Access Compliance Report

Public Rights-of-Way

Intersection ID: 24760	Main Street: S_TRYON_ST	Cross Street: WRIGHT'S_FERRY_RD	Location: N
ADA ID: 7871B9EEDAA2	Ramp Type: PerpDiag	Initial Pass/Fail: Pass	Overall Compliance: No
		Severity Score: 0

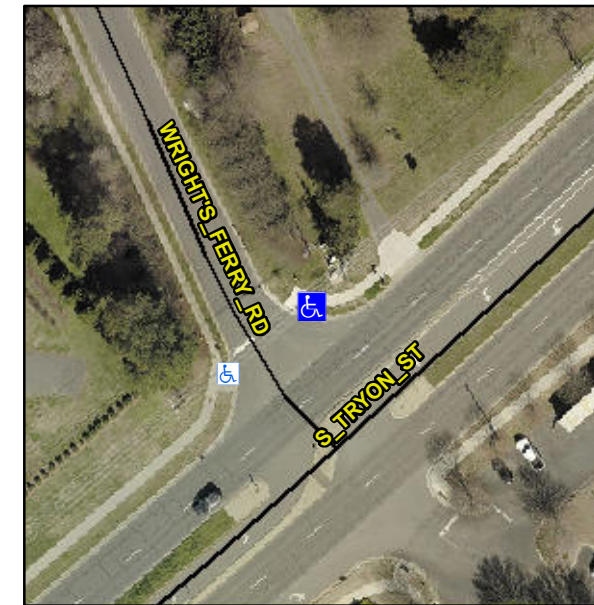
Not Found, R305.2

Remove & Replace Curb Ramp With Two New Directional Ramps or Equivalent.
